**DEVELOPMENT CONSENT AUTHORITY  
LITCHFIELD DIVISION**

**AGENDA ITEM:** **3**      **MEETING DATE:** 13 December 2024      **FILE:** PA2024/0266

**APPLICATION:** Outbuilding (Shed) addition to an existing dwelling – single with a reduced building setback to the side boundary.

**LOCATION:** Section 5251 (95 Thorak Road) Knuckey Lagoon (**Bookmark A**)

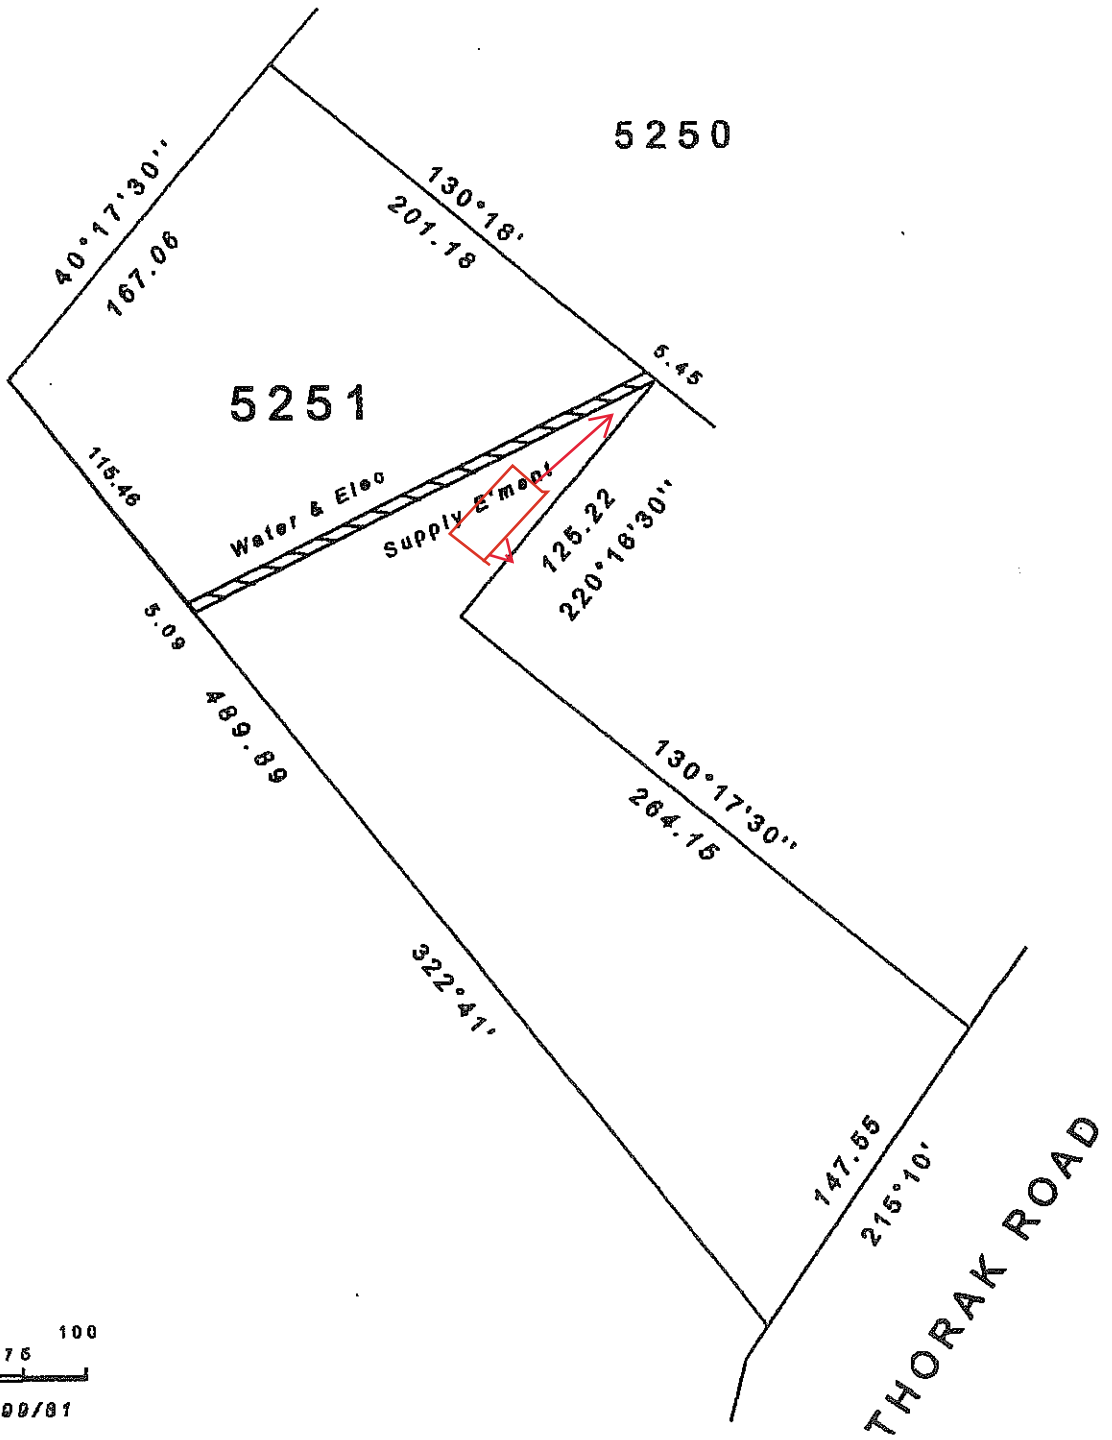
- Provide a professionally dimensioned and to scale site plan (the submitted plans are not to scale), showing site constraints including easements, trees, and existing buildings, to justify the location of the new building.
- There is reference in email correspondence about an existing helicopter landing site on the Lot; this needs to be included on the plans too.
- Confirm the location of the roller doors on the updated site plan.
- Further justification as to why the proposed building needs to be located only 2m away from the boundary, and / or:
- Demonstrate better or total compliance with the NTPS setback requirements, by changing the building location or reducing its footprint.

The Applicant has submitted a plan (not to scale) showing approximate locations of existing constraints on the site (**Bookmark B4**). However, this is not considered sufficient justification to why this significantly (80%) reduced setback is needed and the required 10m cannot be met, as the plan as submitted shows there is space on site for an alternative shed location.

Revised plans and / or further justification has been sought from the Applicant to address the non-compliance with the NTPS identified above.

SCALE A3 SHEET 1:250	DRAWING NUMBER <b>430559-GA</b>	REV <b>A</b>	PAGE <b>8/8</b>
-------------------------	------------------------------------	-----------------	--------------------

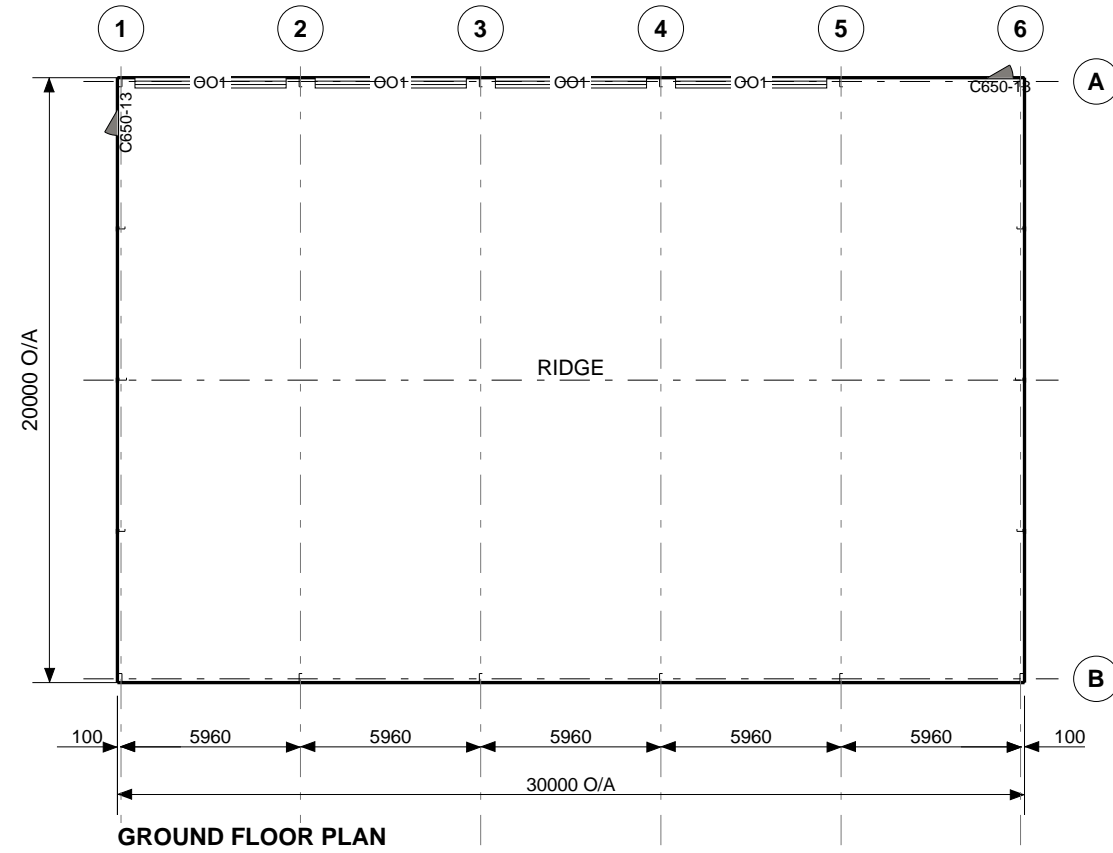
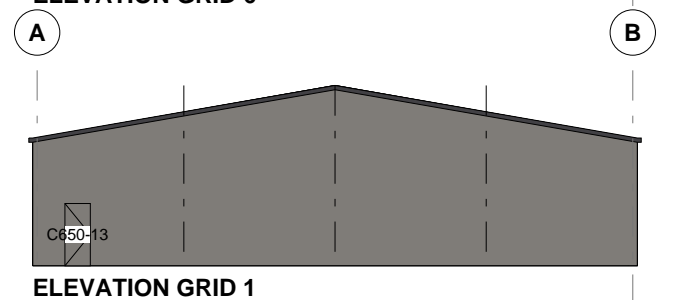
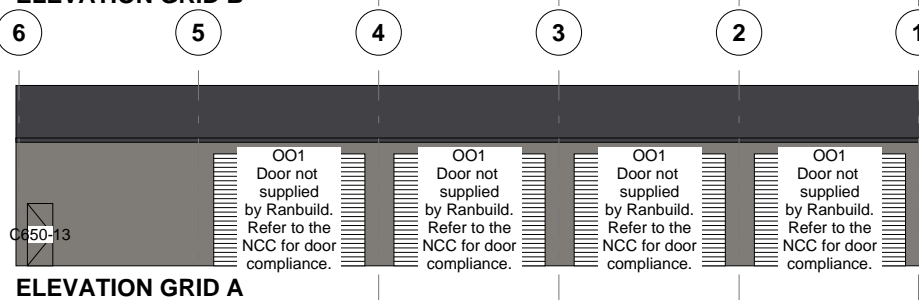
The submitted engineering plans (**Bookmark B7**) also illustrate the presence of four large roller doors. The plans as submitted do not confirm the location of these doors. Updated plans have been requested from the Applicant. It is considered these doors may result in adverse amenity impacts on neighbouring property by enabling noise, dust, and odour transmission, depending on where they are located.

Four large roller doors are proposed, and the presence of these roller doors may impact neighbouring amenity by enabling transmission of noise, dust, and odour impacts.

- Confirm the location of the roller doors on the updated site plan.
- Further justification as to why the proposed building needs to be located only 2m away from the boundary, and / or:
- Demonstrate better or total compliance with the NTPS setback requirements, by changing the building location or reducing its footprint.
